RE: Environics USA Chempro 100 Material License #45-23885-02E

A new application for registration of the Environics USA Inc Chempro 100 was previously submitted and approved. We are requesting the following changes be incorporated into an amendment to the device registration. Except for the following changes, previous commitments for the Chempro and its distribution shall be honored by Environics USA.

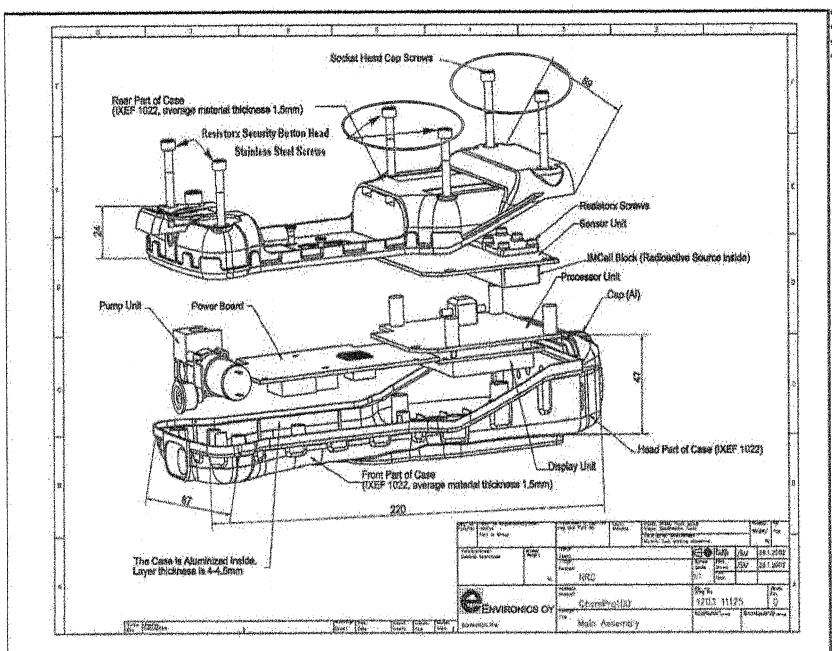
- 1. The phillips screws that are used to attach the belt clip will add the torx screw already used as an alternate part for producibility purposes; see attached drawing with the screws highlighted and spec sheet.
- 2. The label on the front marked Chempro will be removed to allow for branding of the device for specific markets (i.e. Drager MultiIMS for the Firefighters, etc.). See attached figure. All radiation labeling is unchanged. Specific labels will be added for the specific customer or market prior to shipment similar to the smoke detector market. This does not impact the safety or the operation of the device.
- 3. Add new facility located at 4420 Eastport Parkway, Port Orange, FL 32127 to block 12 of license as an additional distribution point.

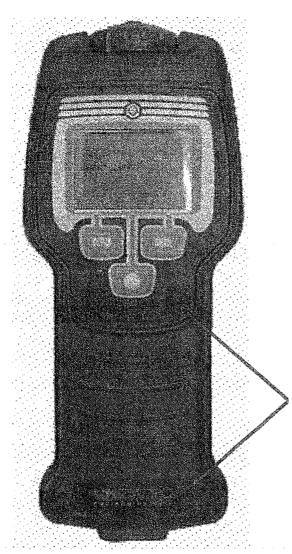
Labels to be removed
